TO: Chairman Phillip Beard, City of Buford  
ATTN TO: Kim Wolfe, City Clerk/Planning Director, City of Buford  
RE: Development of Regional Impact (DRI) Review  
FROM: Mike Alexander, ARC Center for Livable Communities

**Name of Proposal:** IDI/Gravel Springs Road DRI 3558

**Description:** A DRI review of a proposal to build a one-story building with 1,026,813 SF of industrial space on a 58.2 acre site south/southwest of the SR324/Gravel Springs Road and north of I-85 in the City of Buford in Gwinnett County. Currently roughly half of the site is forested and the other half used for agricultural purposes and several single-family homes. Three driveways are proposed on SR324/Gravel Springs Road. A total of 337 car parking spaces and 197 truck/trailer drops are included.

DRI SITE PLAN

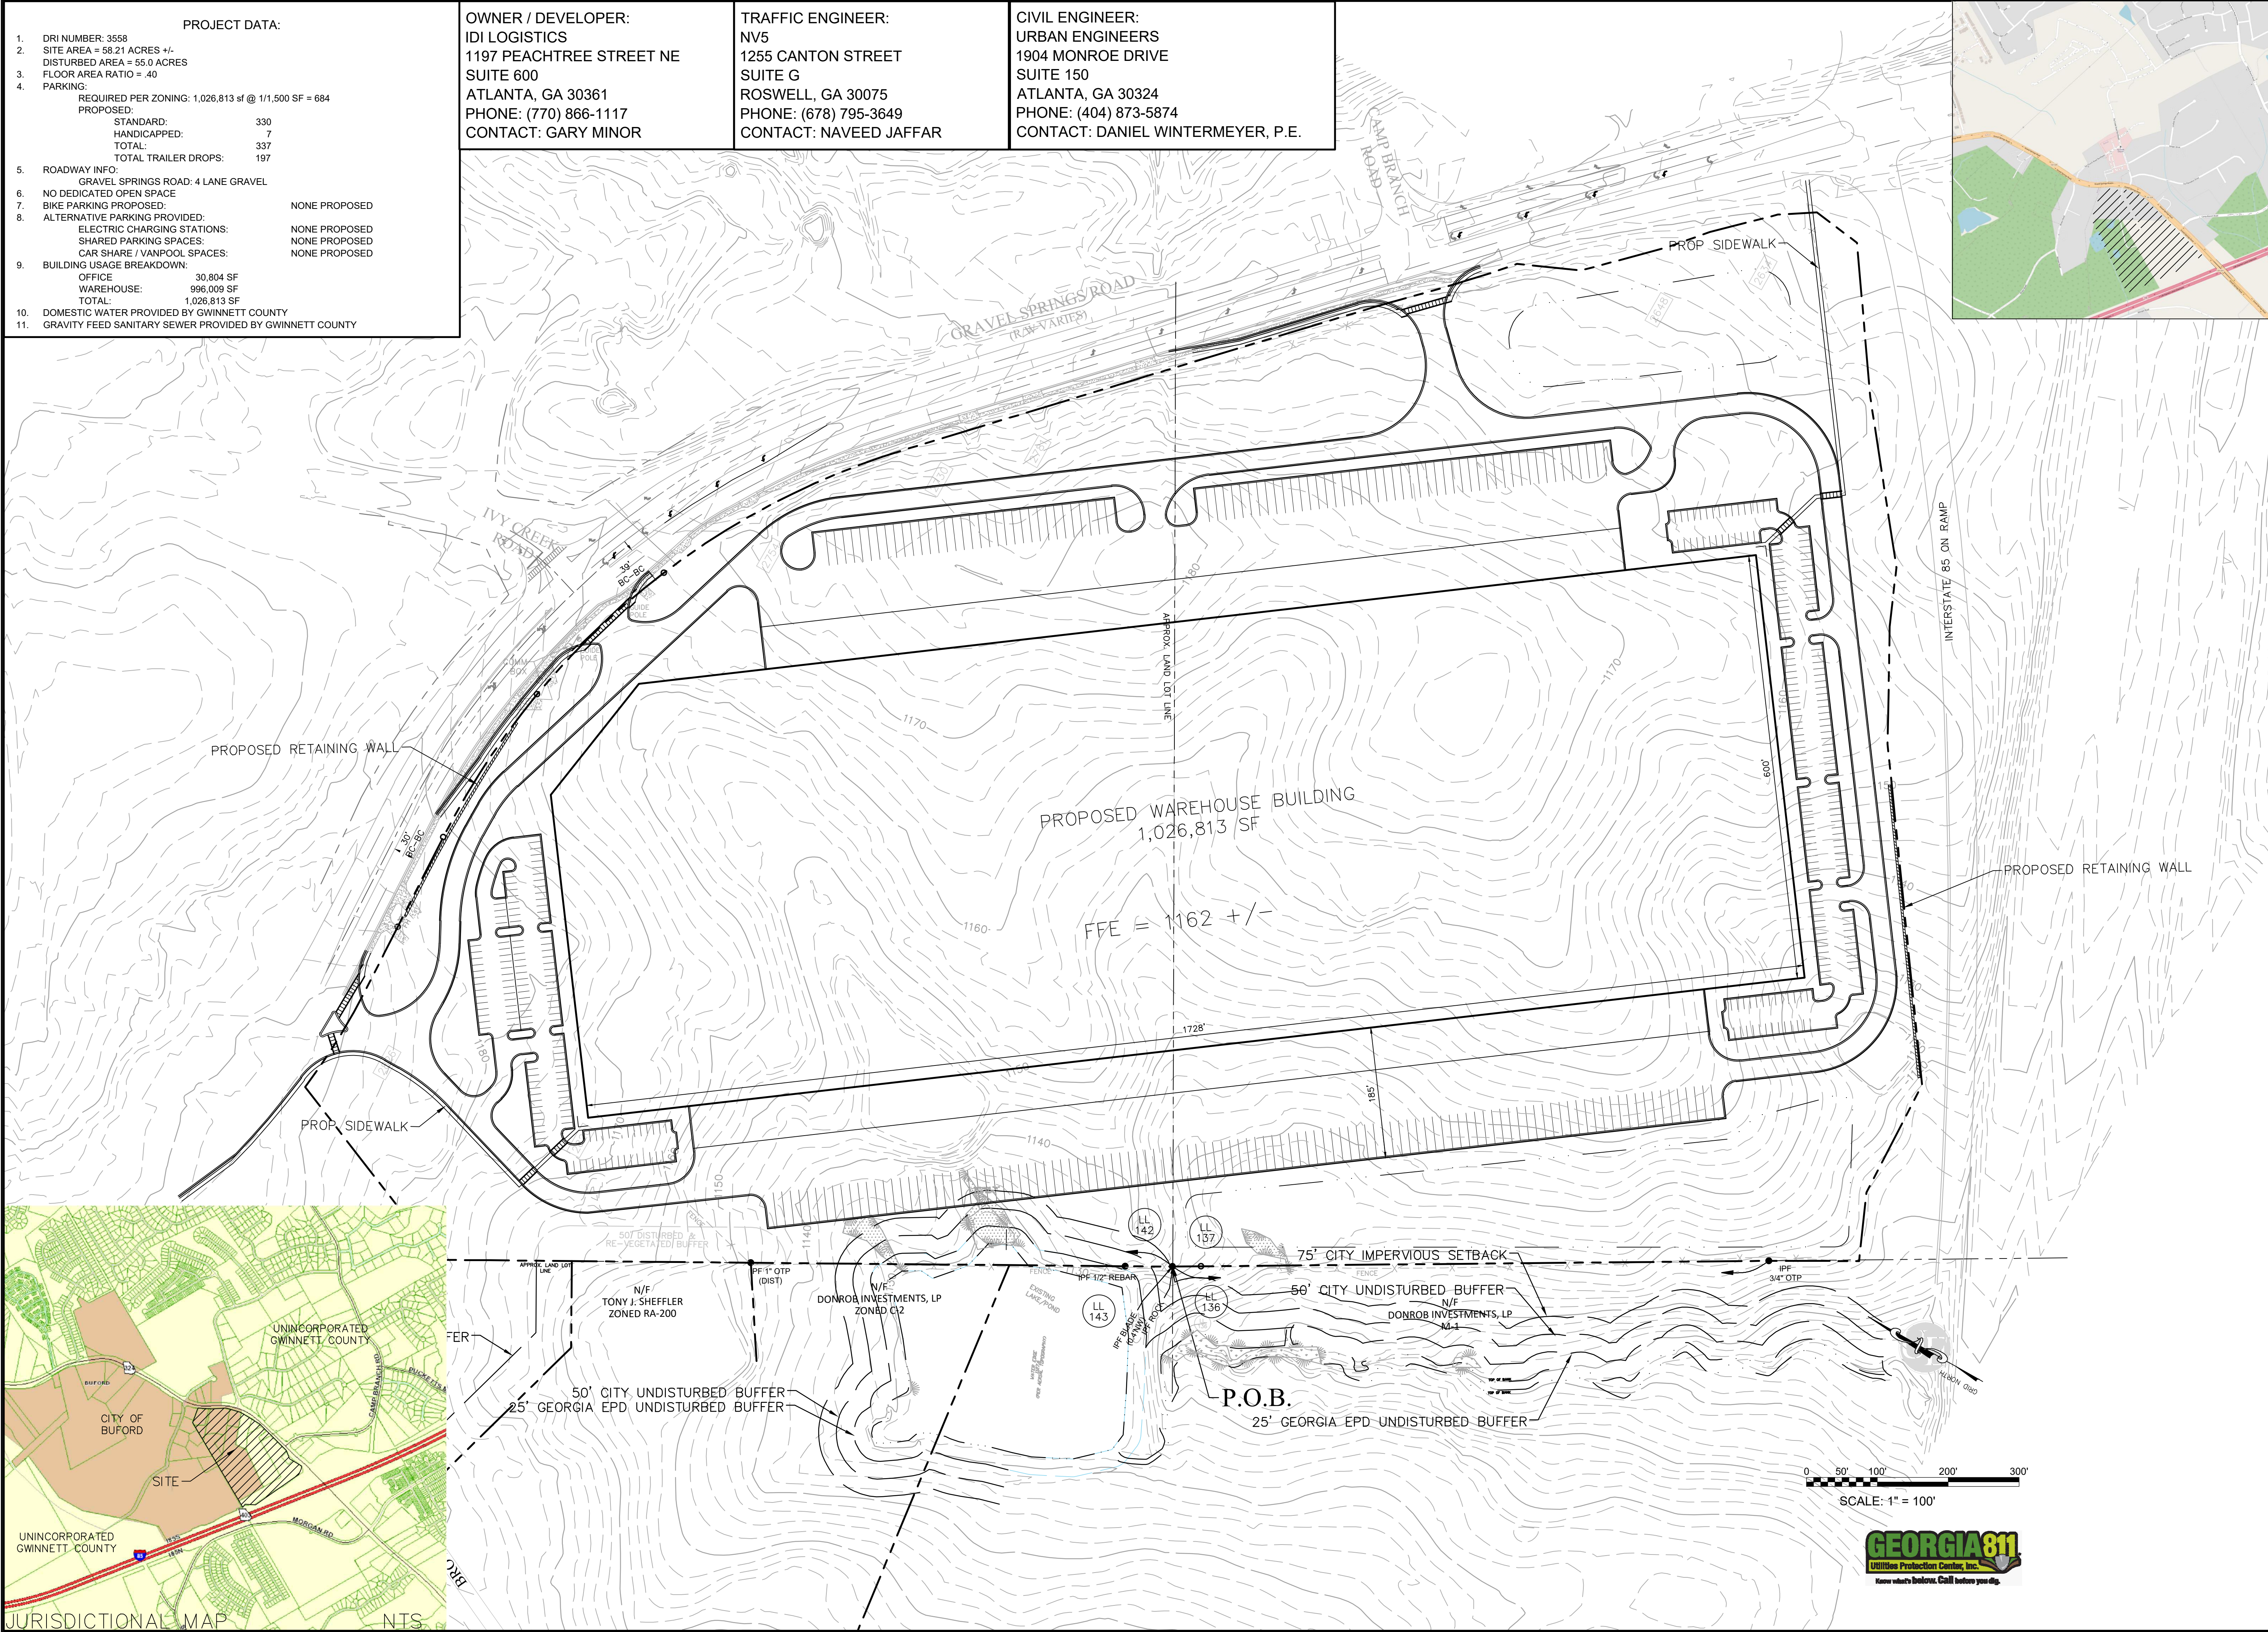
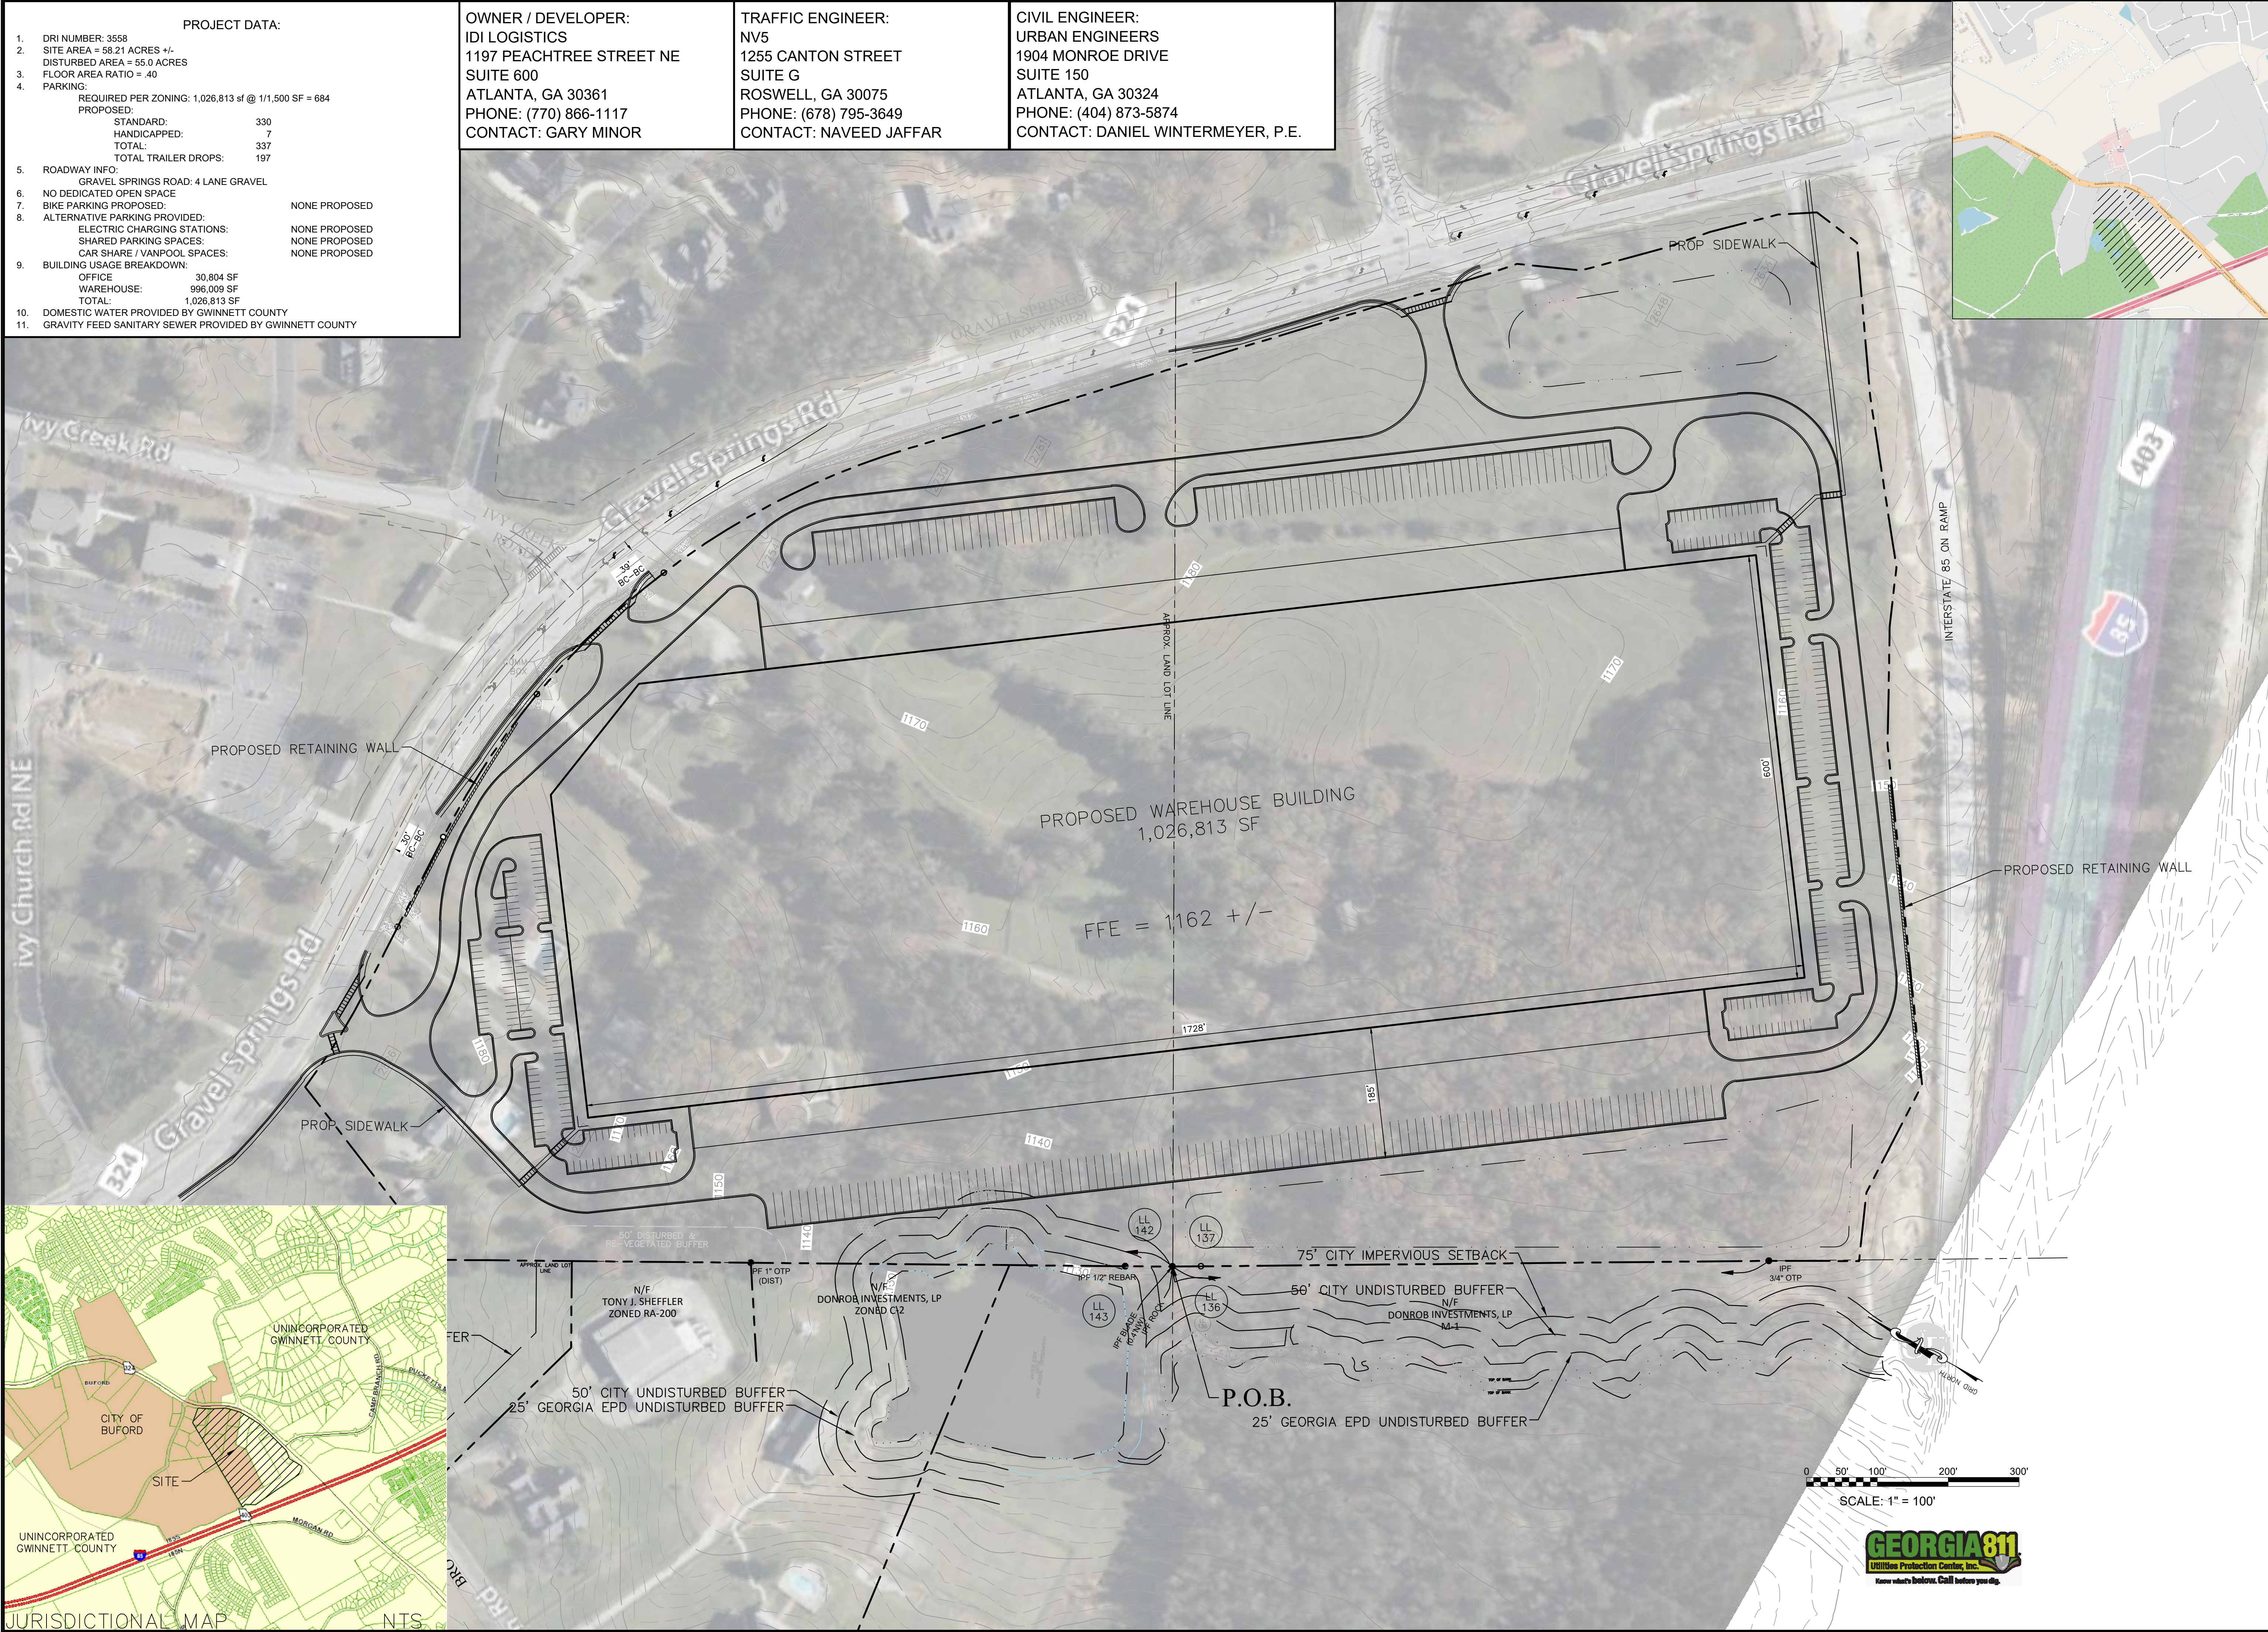
*The parking area on the south side of building intrudes into stream buffers and may require City variances.*

The site plan shows a small lake and stream mostly located within the adjacent properties to the south. Regulated stream buffers from these offsite water elements extend into the site. The parking area on the south side of the building intrudes into the stream buffer. A state and/or city variance may be needed to allow this intrusion.

The southern half of the site is mostly wooded; additional retention of existing trees on the site would be desirable and in keeping with regional goals regarding carbon sequestration and climate change/heat island effect mitigation.

No EV charging stations are proposed; inclusion of some EV charging stations would be supportive of regional EV infrastructure development plans.
